2.5 Geology, Seismology, and Geotechnical Engineering

2.5.1 Basic Geologic and Seismic Information

**Figure 2.5.1-4 - Local Charleston Tectonic Features
(Reproduced from SSAR Figure 2.5.1-19)**

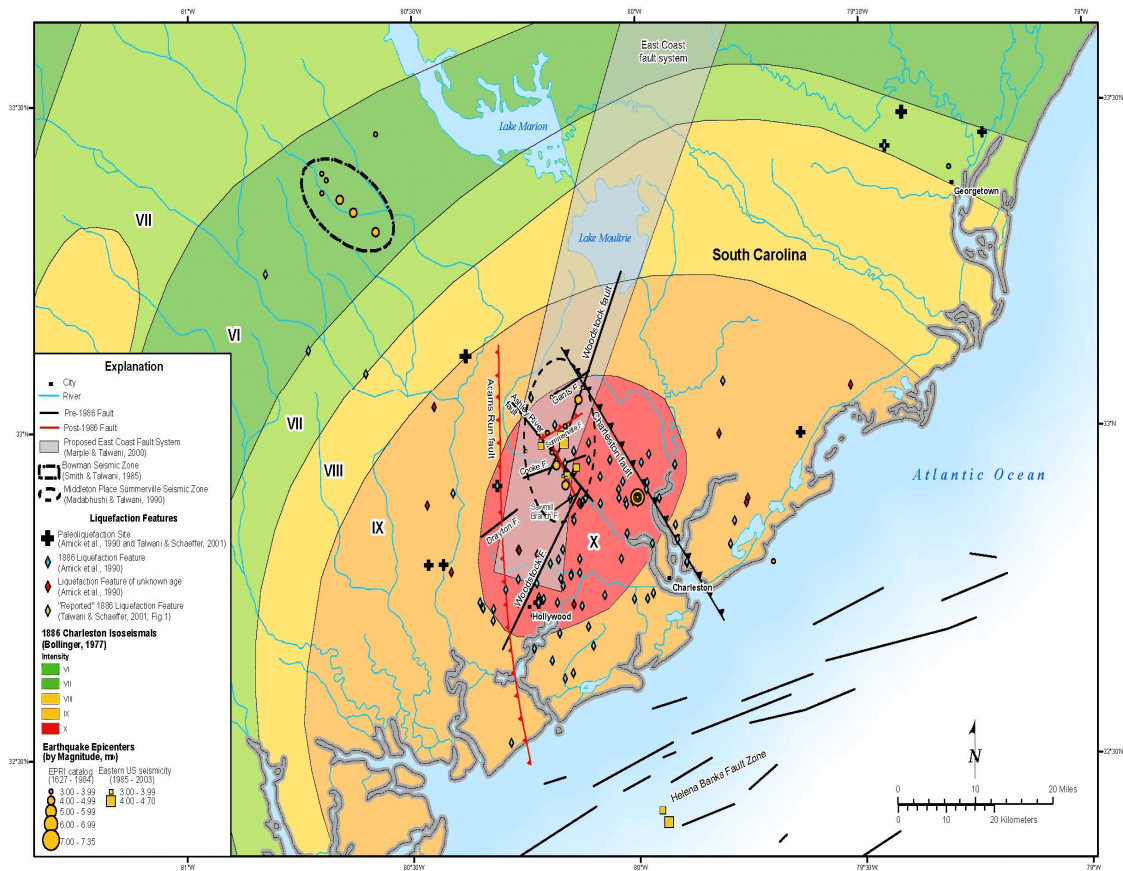
3. The applicant described the Adams Run seismic zone, located within the meizoseismal area of the 1886 Charleston earthquake as being defined by four earthquakes with magnitudes less than M2.5. Three of these four earthquakes occurred over a 2-day period in December 1977. This seismic zone occurs about 120 km (75 mi) east-southeast of the VEGP site and is not shown in Figure 2.5.1-4 as the text indicates.

Figure 2.5.2-2 - Alternative geometries comprising the UCSS model updated Charleston seismic source (reproduced from SSAR Figure 2.5.2-9)

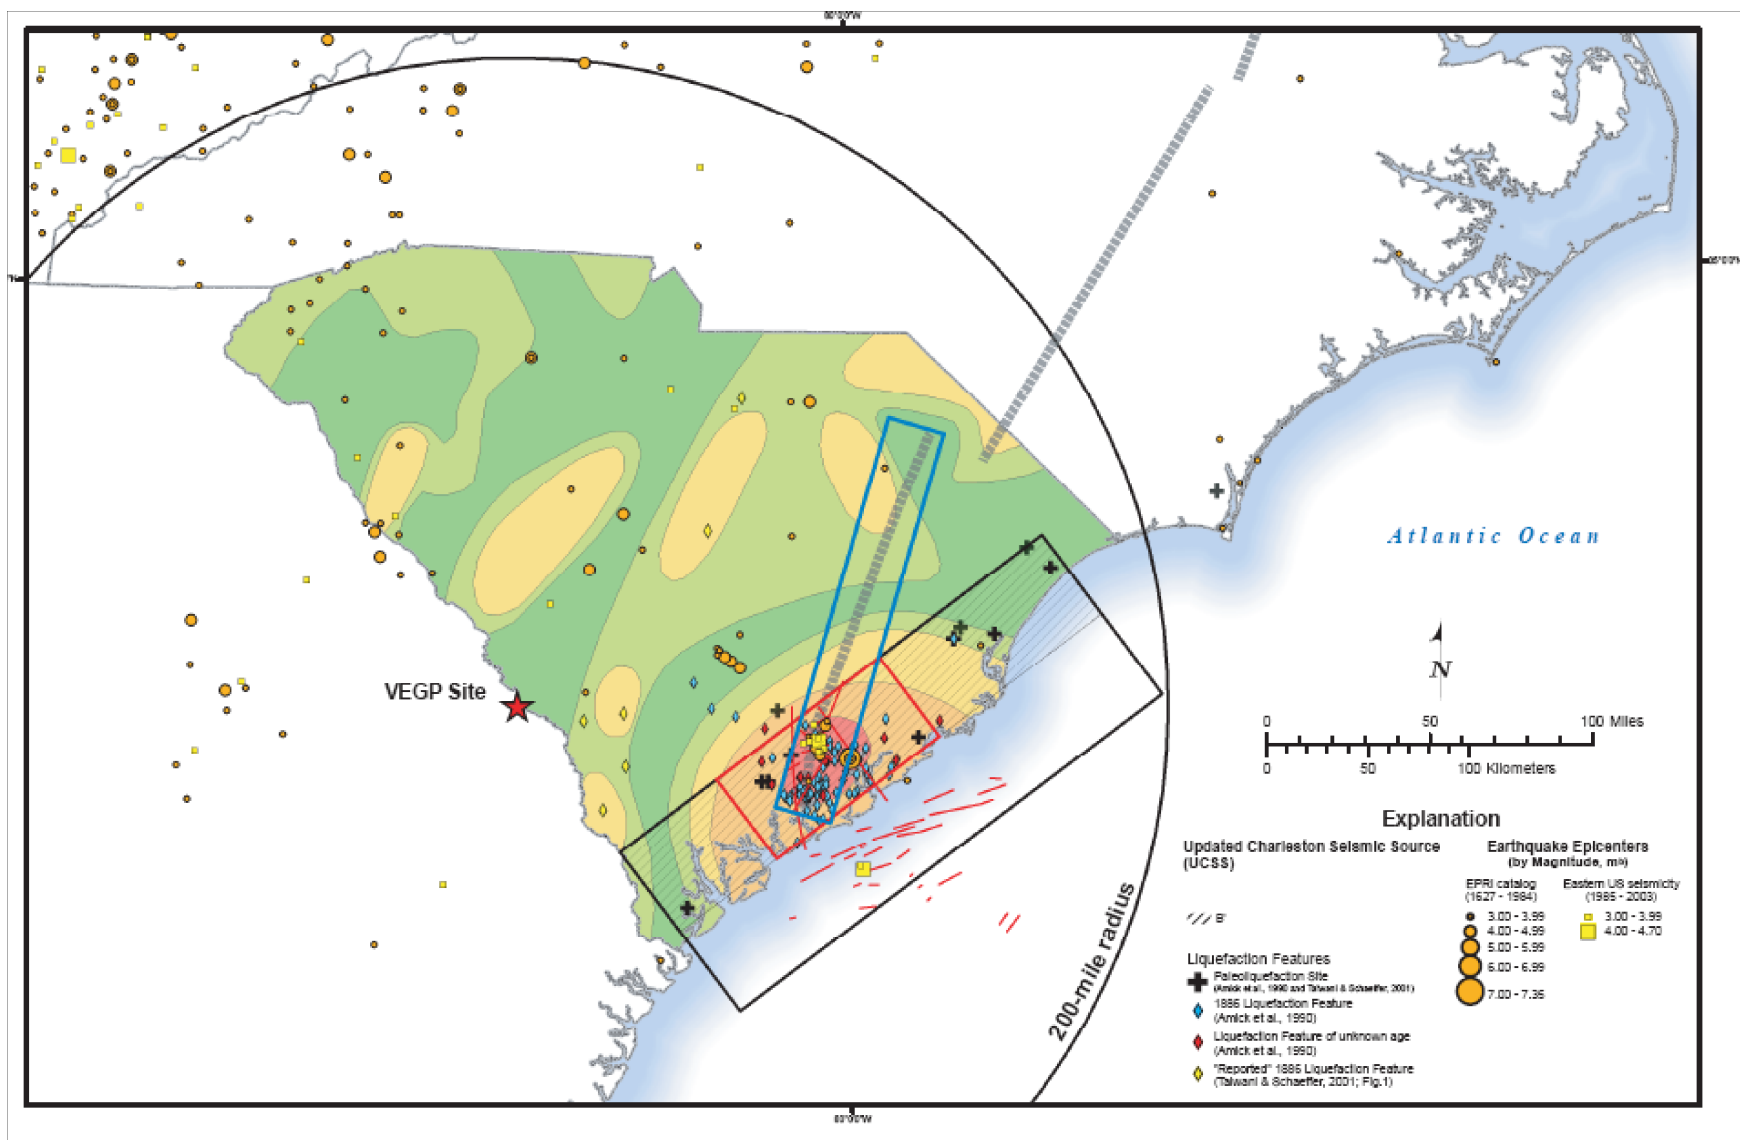
Charleston Seismic Source Zone Geometries. For its update of the Charleston seismic source zone, the applicant developed new source zone boundaries. Specifically, as described in SSAR Section 2.5.2.2.4, the applicant developed four, mutually exclusive source zone geometries, referred to as A, B, B', and C, to represent the Charleston seismic source. These four source zones are shown in SER Figure 2.5.2-2 (reproduced from SSAR Figure 2.5.2-9). SSAR Section 2.5.2.2.4.1 states that the width of Geometry B is 80 kilometers (50 miles). However, SSAR Figure 2.5.2-9 (and SER Figure 2.5.2-2) show that

the width of Geometry B is 100 kilometers (62 miles). In RAI 2.5.2-14, the staff asked the applicant to provide the actual dimensions of Geometry B used for the UCSS. In response, the applicant stated that the width of UCSS Geometry B is 100 kilometers and not 80 kilometers, as stated in SSAR Section 2.5.2.2.4.1. Based on the applicant's clarification of the width of source zone B, the staff concludes that the source referred to as Geometry B in SSAR Figure 2.5.2-9 is accurate.

Figure 2.5.2-11 - Comparison of the staff's 1-Hz hazard curves for the ETSZ for magnitudes ranging from M 6.0 to M 7.8

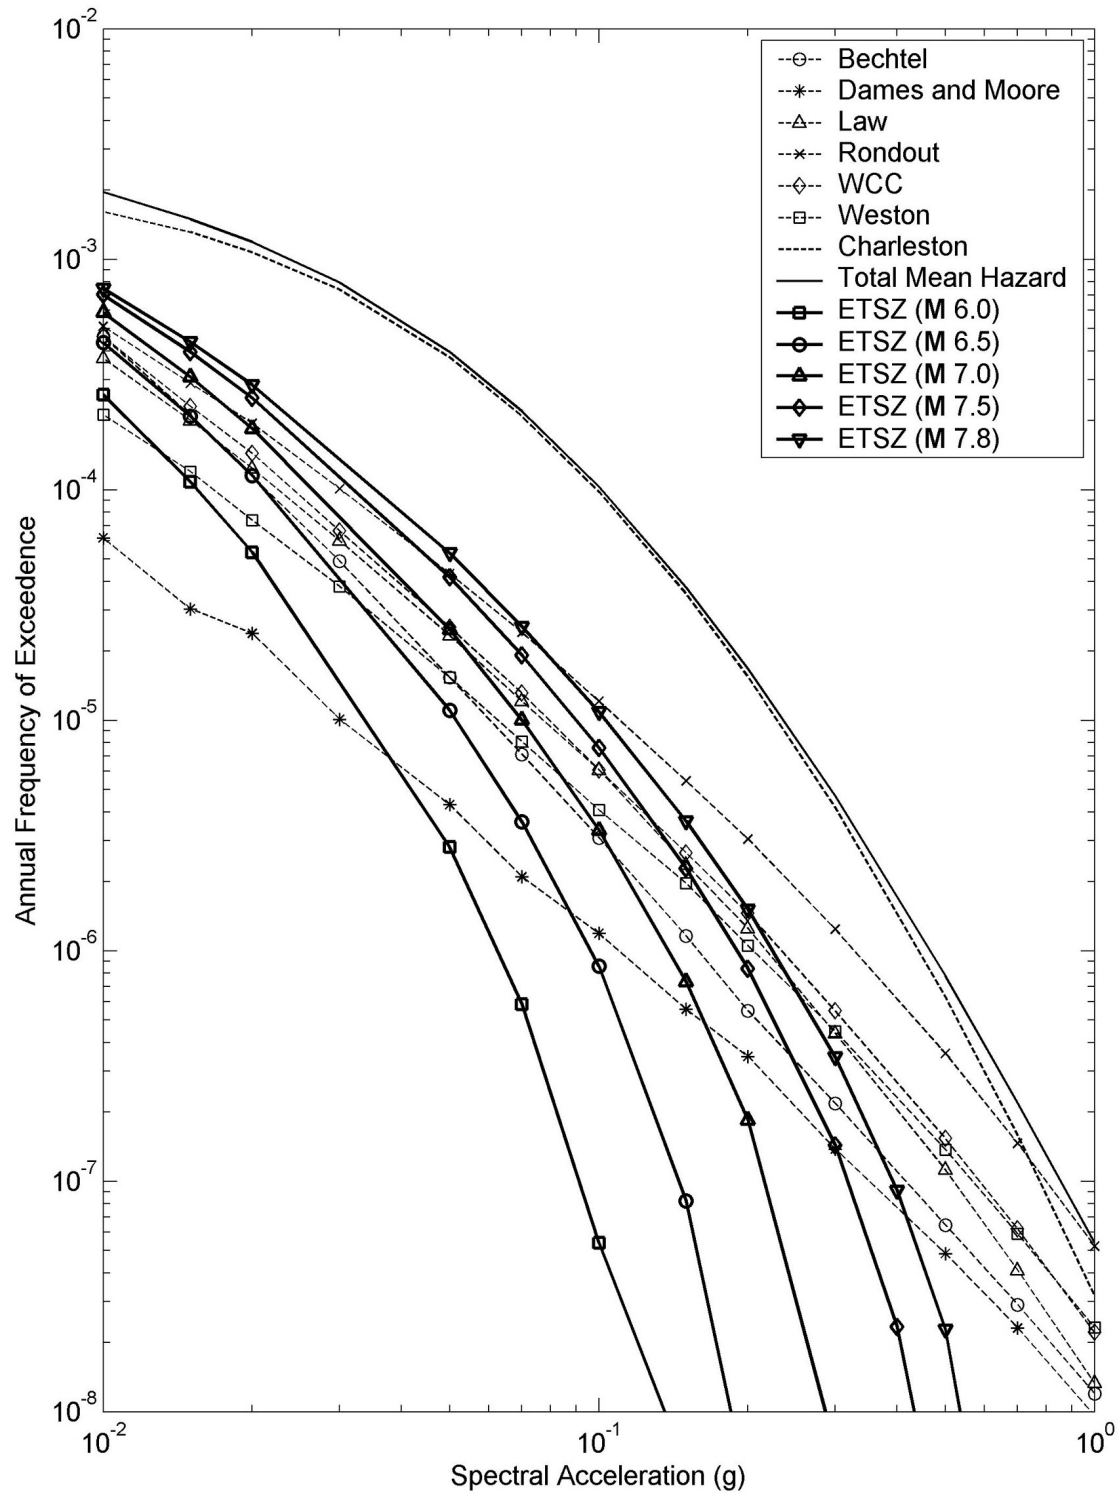
To validate the applicant's claim that the ETSZ hazard results are insignificant compared to the Charleston seismic source, the staff did a confirmatory analysis. The staff performed hazard calculations using maximum magnitudes for the ETSZ that ranged from M 6.0 to M 7.8. This magnitude range reflects more recent M_{\max} values assigned to the ETSZ, as shown in SER Table 2.2.5-6. SER Figure 2.5.2-11 shows the staff's 1-Hz hazard curves for the ETSZ using this range of M_{\max} values. SER Figure 2.5.2-11 also shows the applicant's total mean hazard curve and the Charleston seismic source zone contribution for comparison. The staff's results show that, although the Charleston seismic source zone clearly dominates the 1-Hz hazard, the contribution from the ETSZ for some of the larger M_{\max} values (greater than 7.0) may contribute significantly more than 1 percent to the total hazard for the ESP site.

The staff concludes that, despite the uncertainty regarding the potential for large earthquakes within the ETSZ, the results of post-EPRI source characterizations for the ETSZ suggest that the EPRI EST characterization of the ETSZ needs to be updated. The results of the staff's confirmatory analysis do confirm the applicant's assertion that the Charleston seismic source dominates the 1-Hz hazard. However, the staff concludes that the contribution of the ETSZ at the ESP site may be significant enough to warrant inclusion in the applicant's PSHA, if larger M_{\max} values are considered. This is **Open Item 2.5-3**.

Figure 2.5.2-15 - Results of the staff's site response calculations for high-frequency rock motions for the 10^{-4} hazard level. The applicant's mean results are shown for comparison.

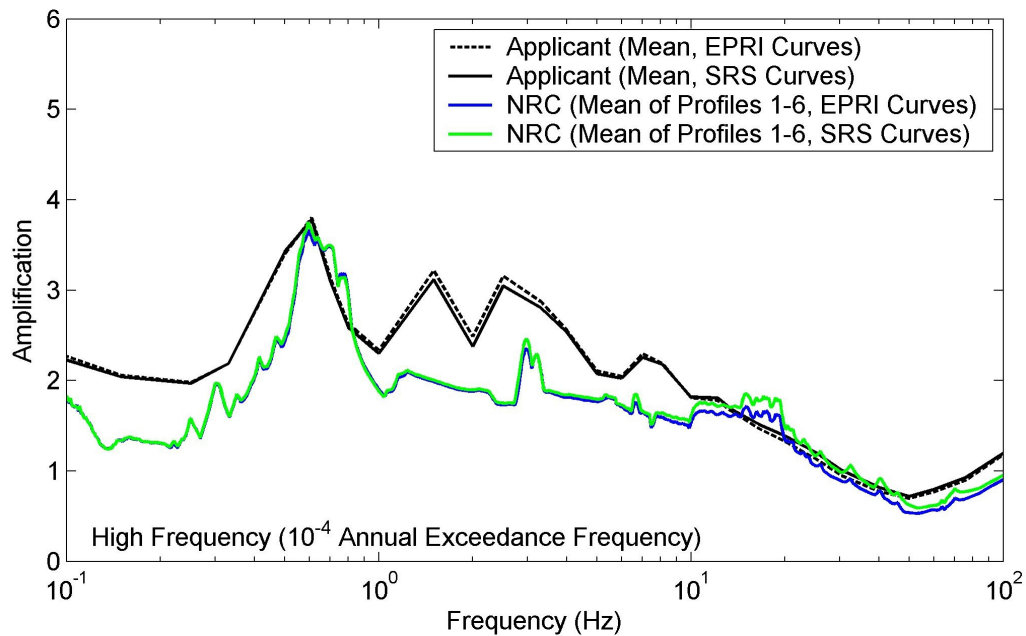
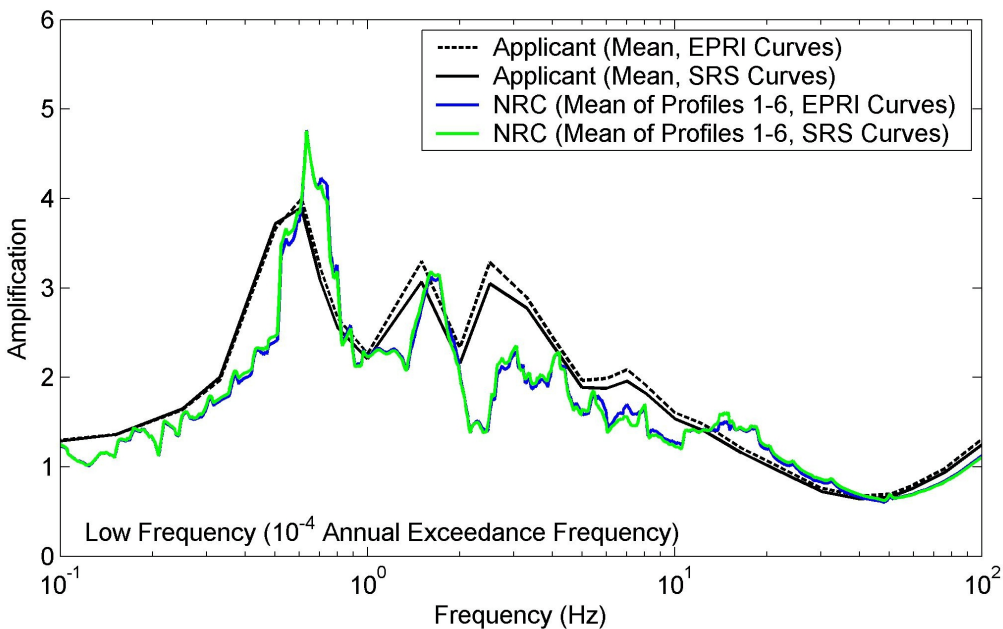
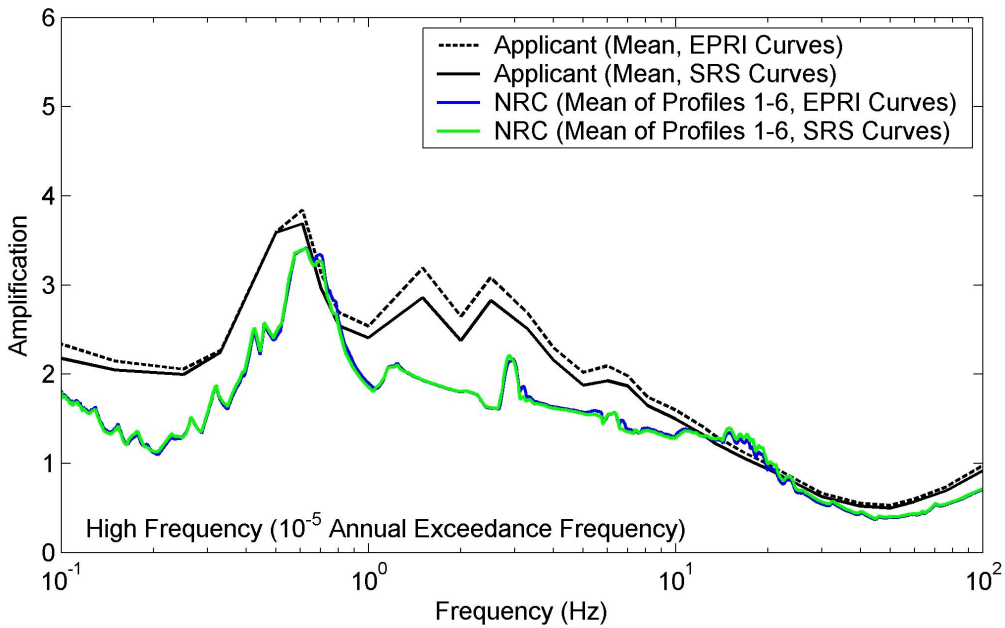
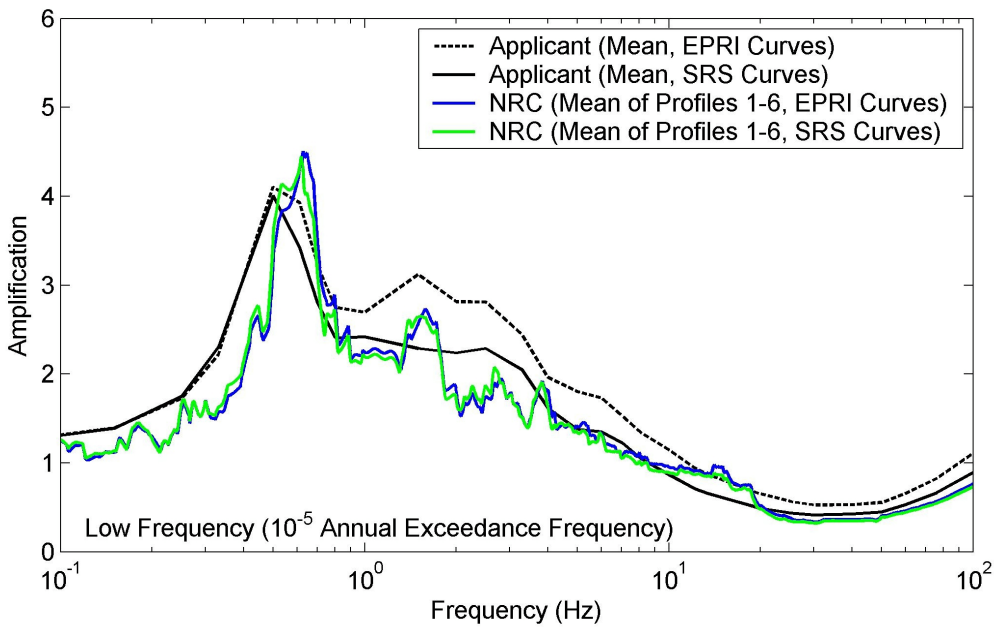
SER Figures 2.5.2-15 to 2.5.2-18 show the mean AFs resulting from the staff's confirmatory site response calculations. Each figure plots the mean results of the six alternative subsurface profiles for both the EPRI and SRS shear modulus and damping curves. SER Figures 2.5.2-15 and 2.5.2-16 show the results corresponding to the 10^{-4} hazard levels for the respective high- and low-frequency input motions, while SER Figures 2.5.2-17 and 2.5.2-18 plot the results corresponding to the 10^{-5} hazard levels for the respective high- and low-frequency input motions. SER Figures 2.5.2-15 to 2.5.2-18 also show the applicant's mean AFs for comparison. The applicant's results are similar overall. For each case, the

amplification peaks are very similar, and in all cases, the peaks occur at approximately 0.6 Hz. The differences between the results are likely due to the greater variability that the applicant incorporated into its model through the use of randomized profiles and material properties, as well as the use of multiple time histories. This variability is illustrated in SER Figure 2.5.2-19 (reproduced from SSAR Figure 2.5.2-37). As a result of its analysis, the staff was able to confirm the applicant's overall site response results.
